SOUTH ELEVATION

NORTH ELEVATION

CONSTRUCTION	
LONDON & NEWCASTLE	
30 OVAL ROAD	
SOUTH ELEVATION & NORTH ELEVATION	
1:100 & A1 & 1:200 & A3	DATE: 26/11/2008

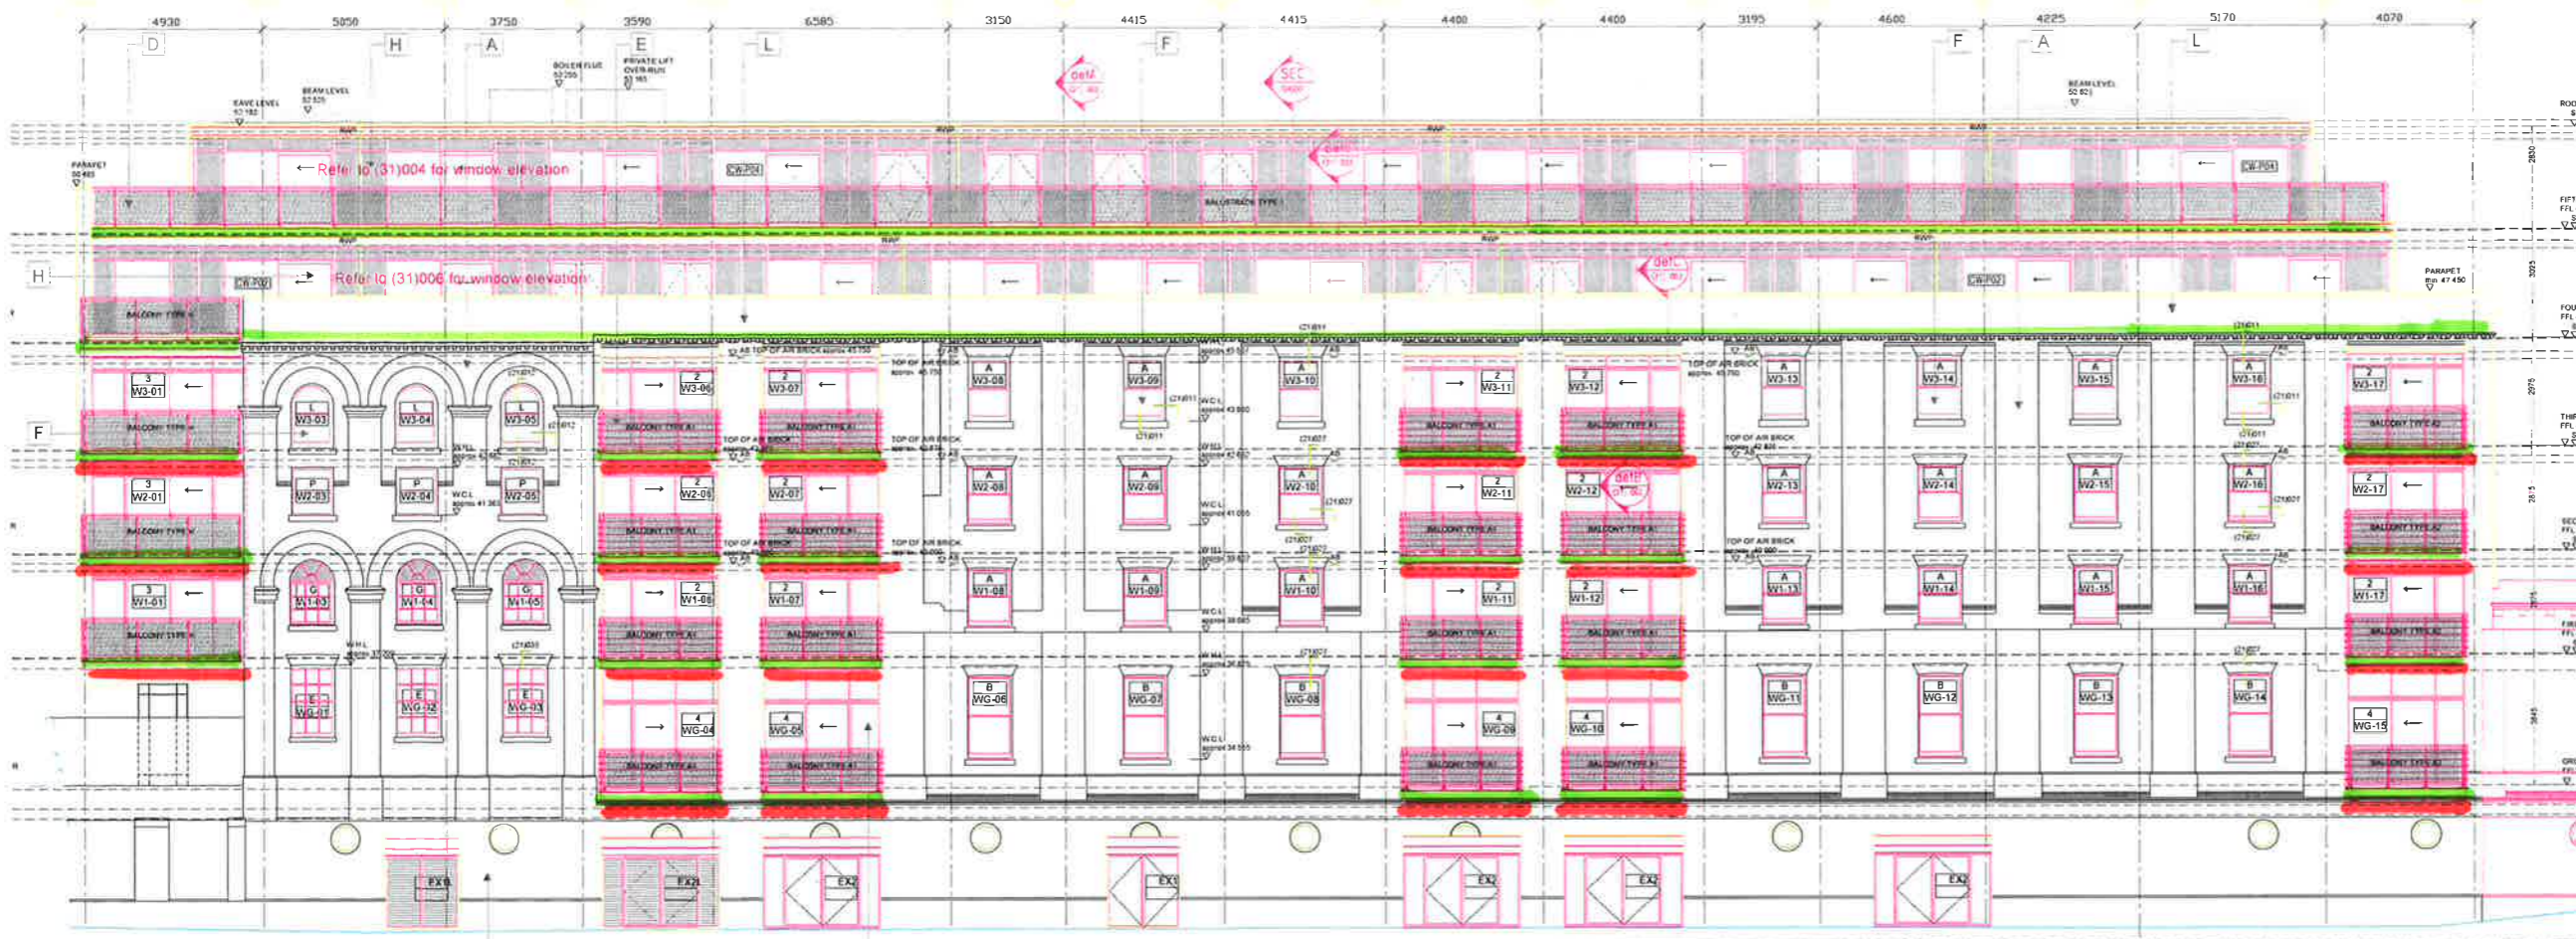
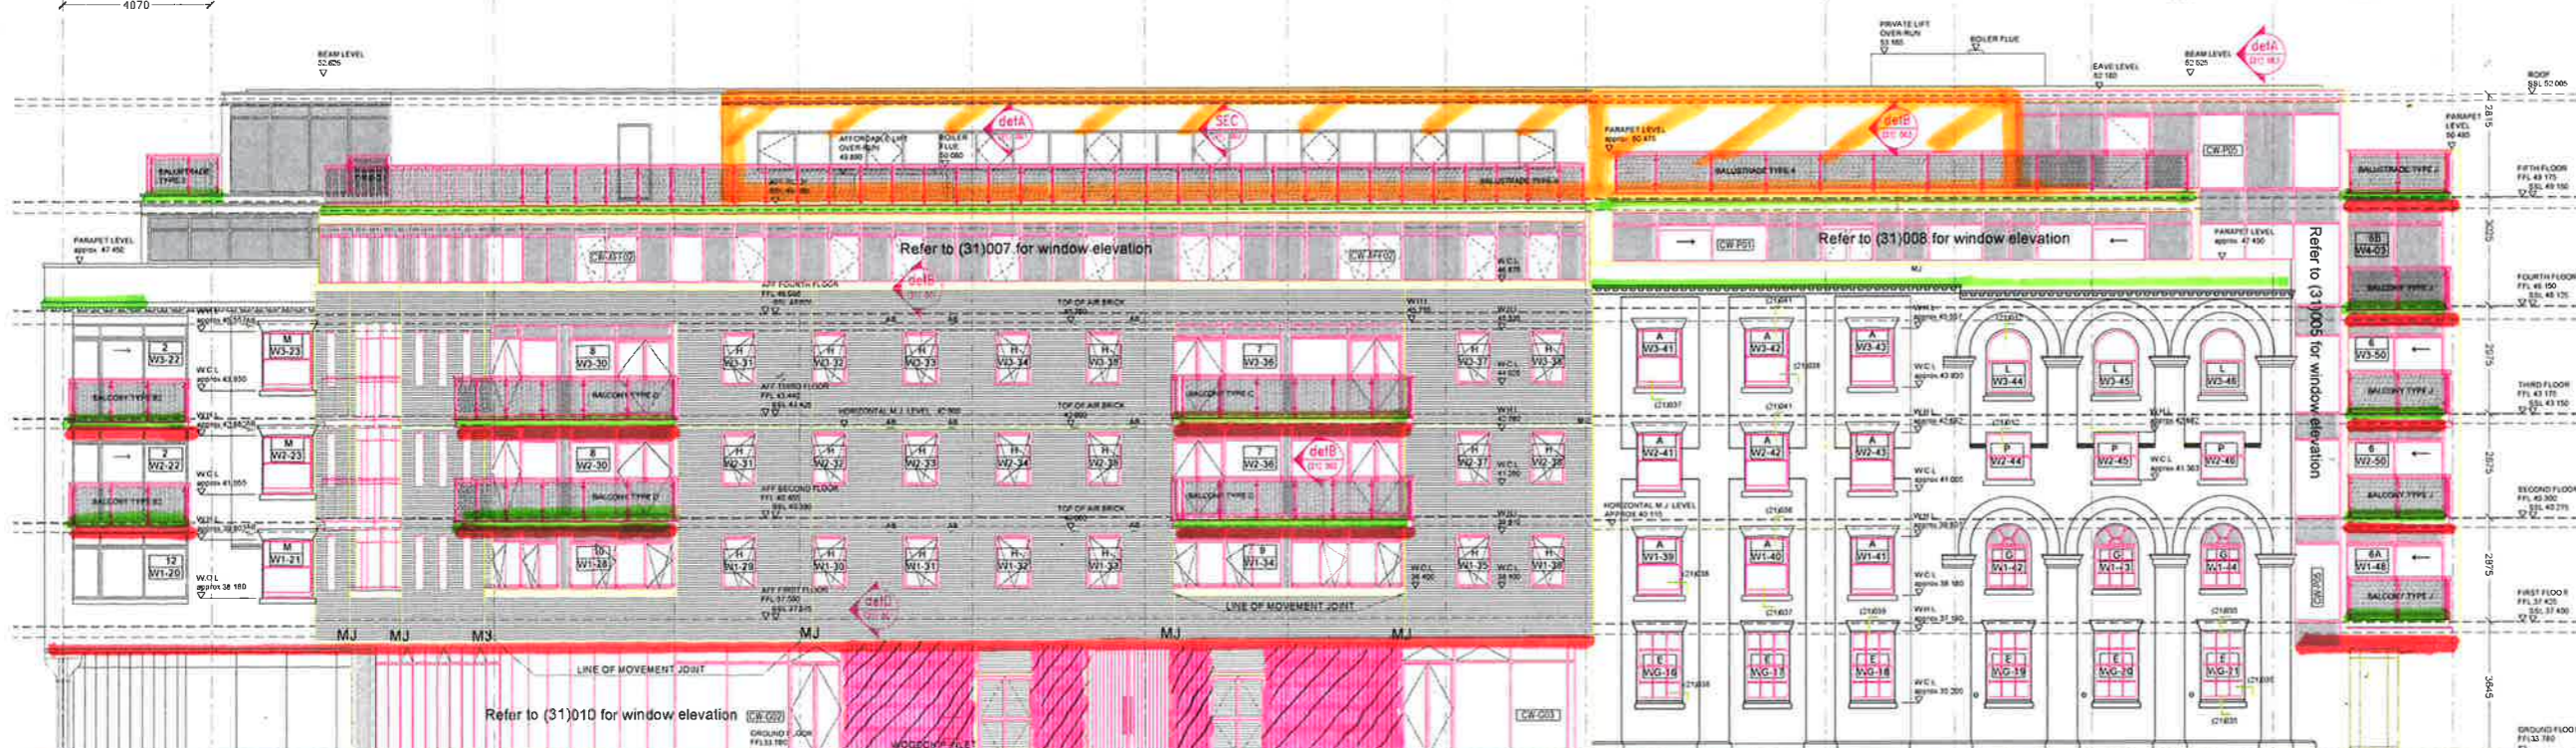
Key - Combustible Materials to be replaced

- █ Timber Decking
- █ Timber Soffits
- █ Vertical Timber Cladding
- █ Render
